CURRENT ISSUES IN THE HIGH-LEVEL WASTE PROGRAM

**Center for Nuclear Waste
Regulatory Analyses**

March 9, 1993

101-V
COMPARISON OF SYSTEMATIC PARAMETERS WITH NRC CRITERIA
EFFECT OF DELAY TIME OF WATER REACHING WASTE

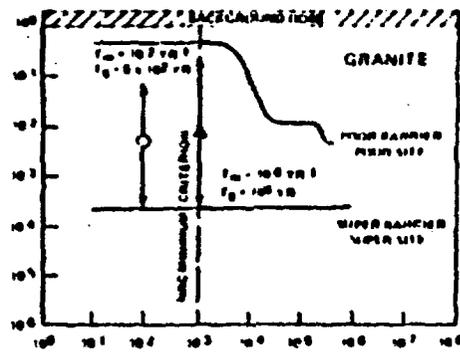
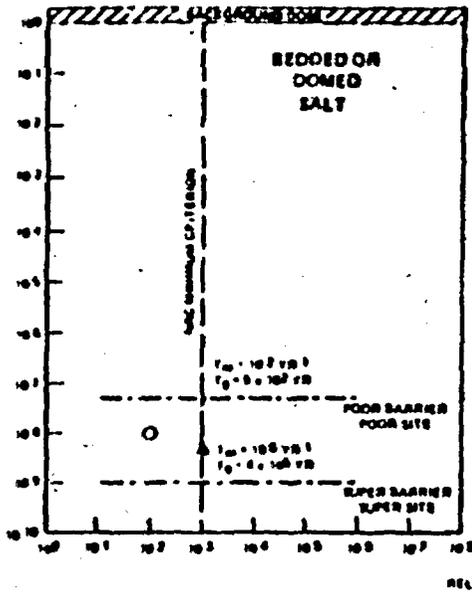
The effect of varying the delay time for water to penetrate the containment over a range of five orders of magnitude is shown in Figure 1. For all three geologic environments, the analysis shows that the effect of a 1,000 year lifetime package is not significantly different from that of a 100 year lifetime package. In all cases the analysis indicates that the maximum exposure is below background.

COMPARISON OF SYSTEMATIC PARAMETERS WITH NRC CRITERIA
EFFECT OF MAN MADE BARRIER

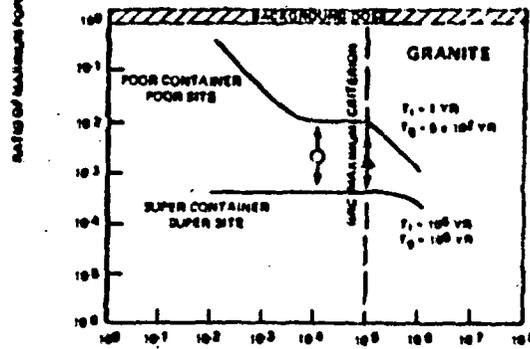
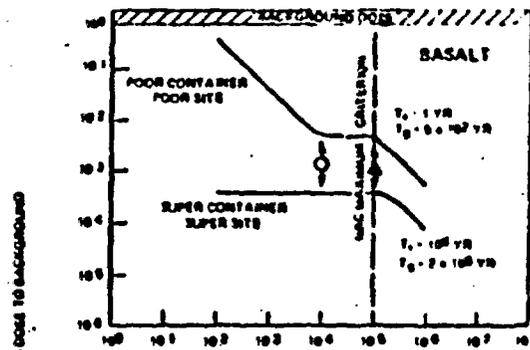
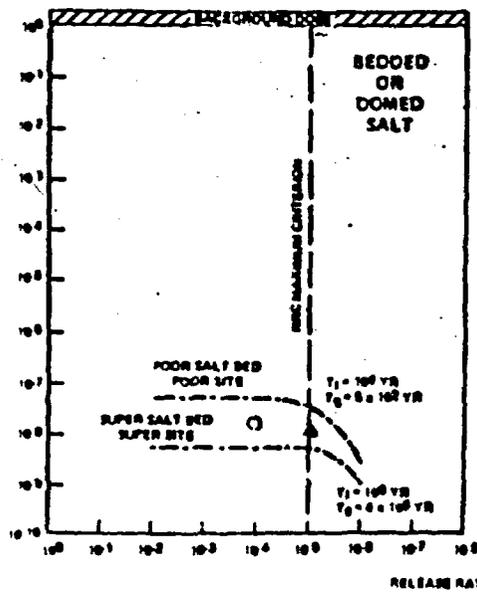
Once containment has been breached, the effect of varying the release rate over a range of four orders of magnitude is shown in Figure 2. There is no significant change in calculated population dose as the waste release rate is increased from the proposed maximum criterion of 10^{-5} fraction per year to a rate of 10^{-4} per year for a nominal repository. Of course, further reductions of release rate toward the theoretical zero release would marginally reduce computed release to the accessible environment, but it is very doubtful that the additional reduction in the maximum exposure below the already extremely low level would be justified.

(01-4)
COMPARISON OF SYSTEMATIC PARAMETERS WITH MRC CRITERIA
EFFECT OF SITE ISOLATION

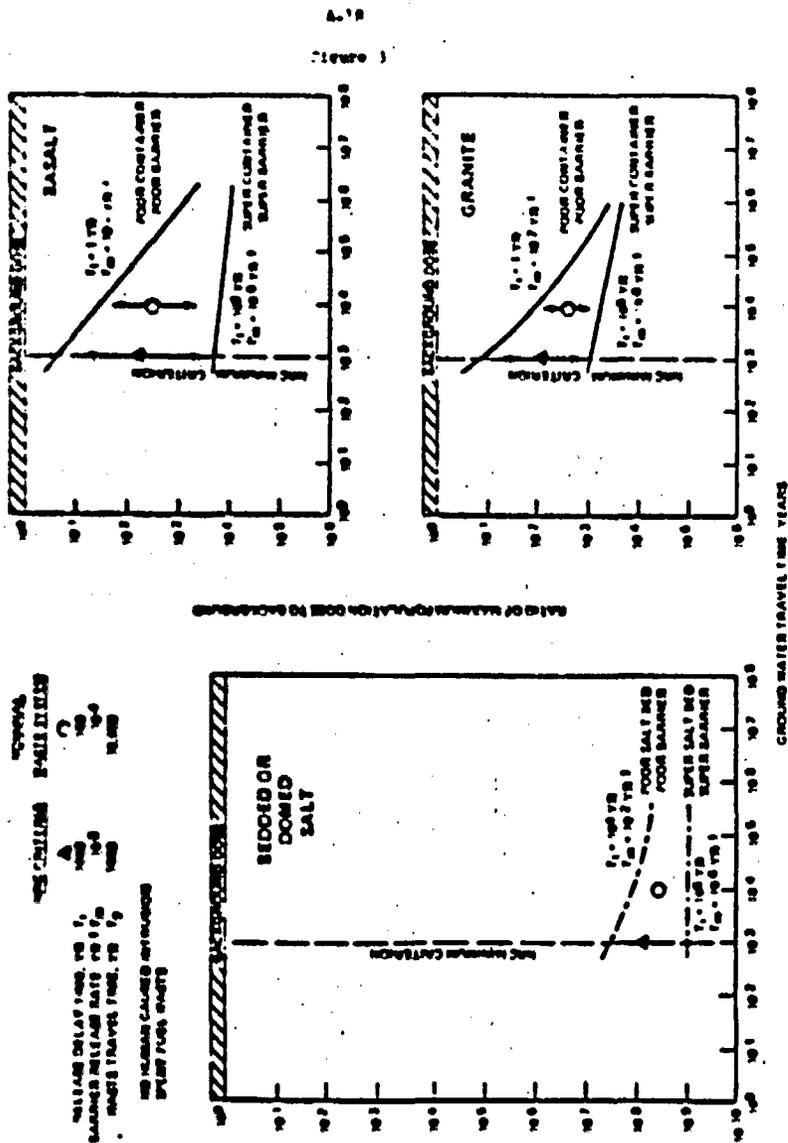
The effect of varying the groundwater travel time from the waste to the biosphere over a 3,000-fold range is shown in Figure 3. The population dose decreases as the travel time is increased over the entire range for both extremes. Thus, it can be seen that the isolation system is by far more sensitive to groundwater travel time than to the performance of the engineered barriers.

Figure 1: Health effects associated with one curie release for the ingestion pathways.

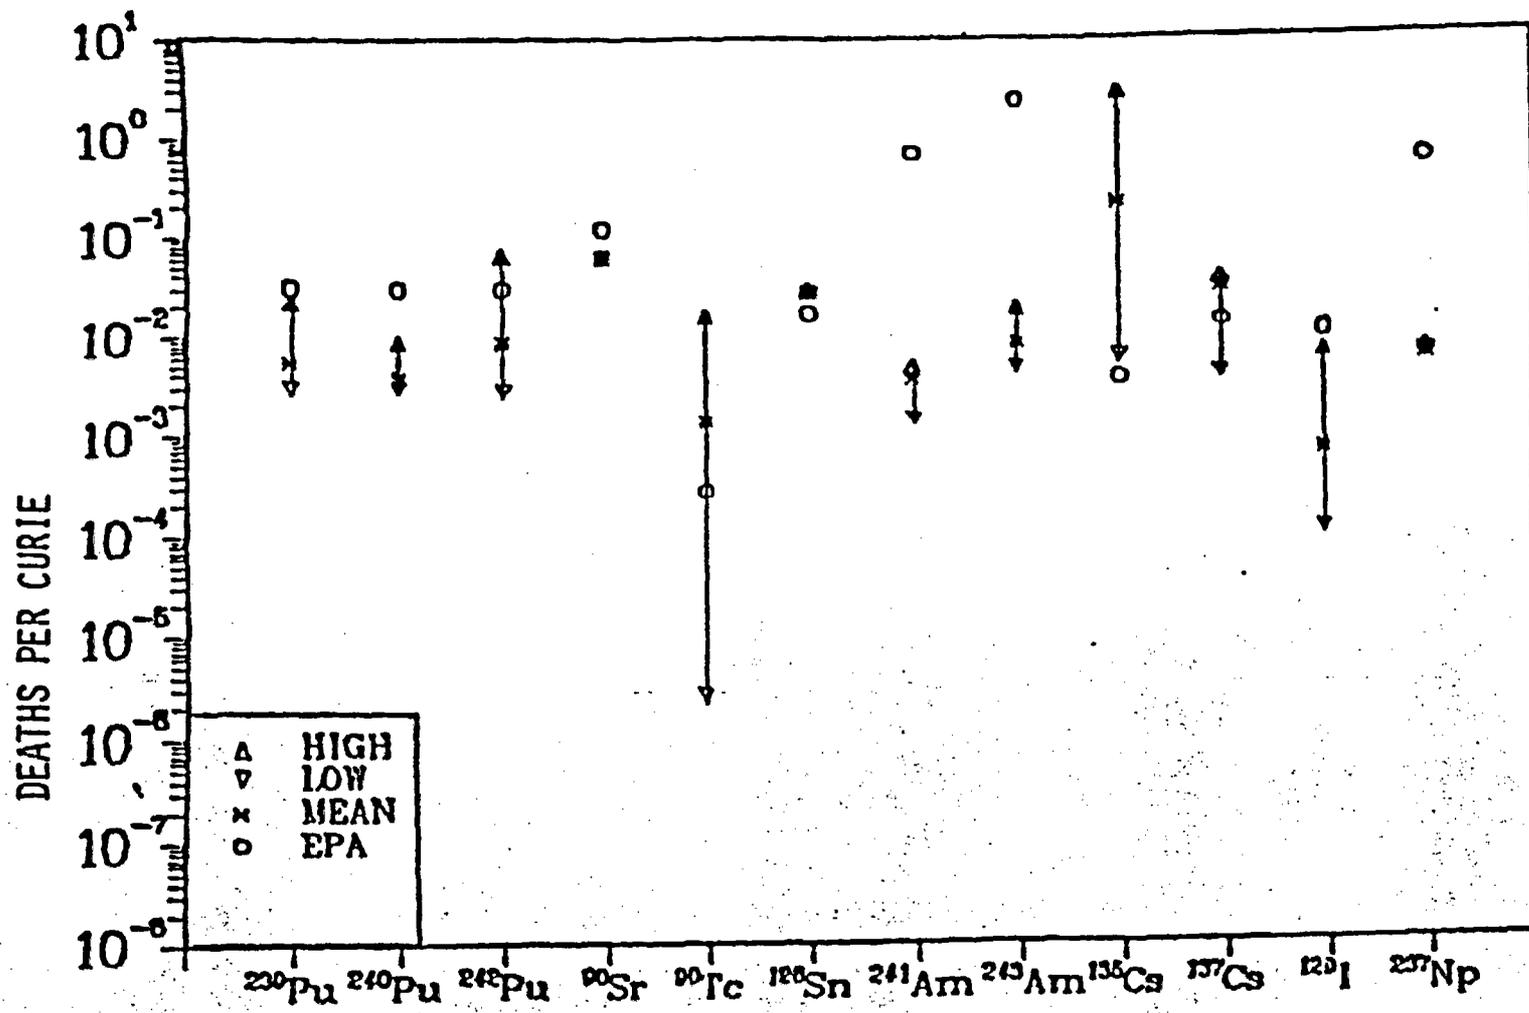
surface water and soil compartments. A sample comparison with the EPA calculation is presented in Figure 1, which shows the health effects associated with one curie of a given radionuclide when the ingestion pathways are considered.

Figure S.3.

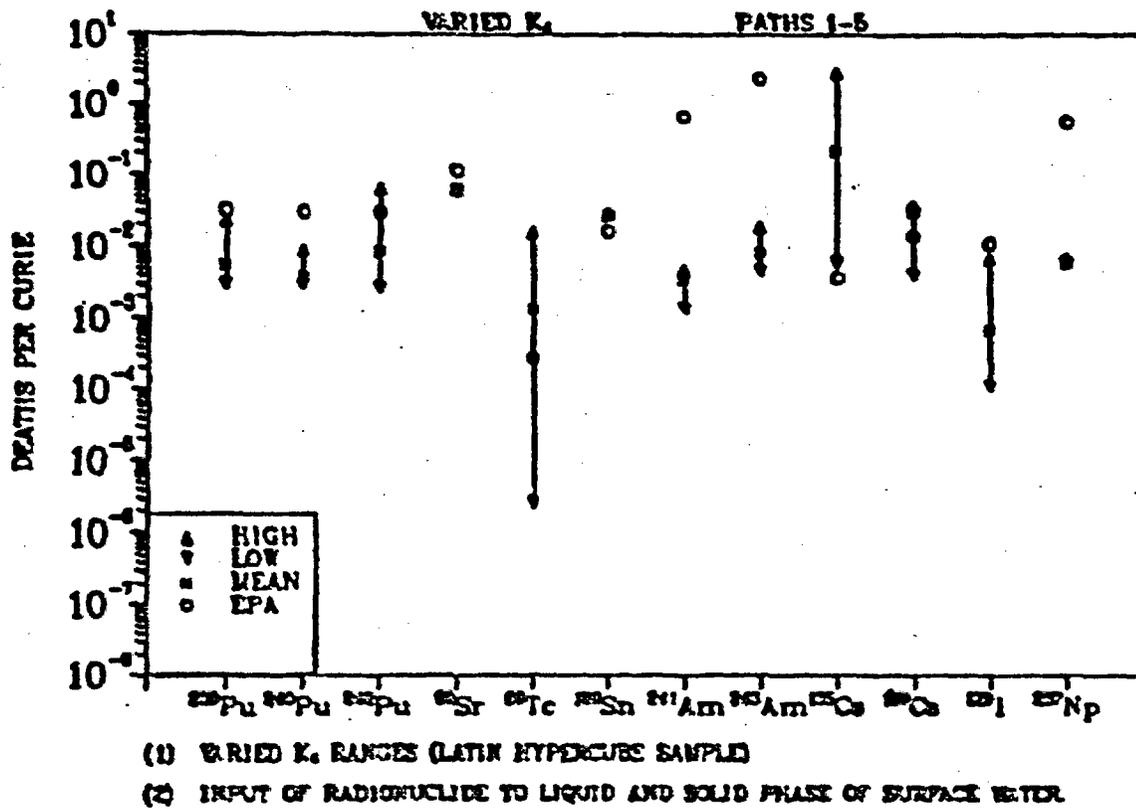
Of note are the EPA values for ^{241}Am , ^{243}Am and ^{237}Np for pathways 1-5 (Figure 5.3). The results of this analysis for ^{241}Am and ^{243}Am indicate that the release limits for these radionuclides may be overly conservative and may warrant a reexamination by the EPA. Also, the EPA release limit for ^{135}Cs would appear not to be restrictive enough from the results of this analysis and again may warrant some reconsideration.

Although these results certainly do not establish that the EPA release limits proposed in the Standard are overly conservative, generally they do suggest that the allowed release limits might be higher if the health effects per curie calculated in this analysis were used.
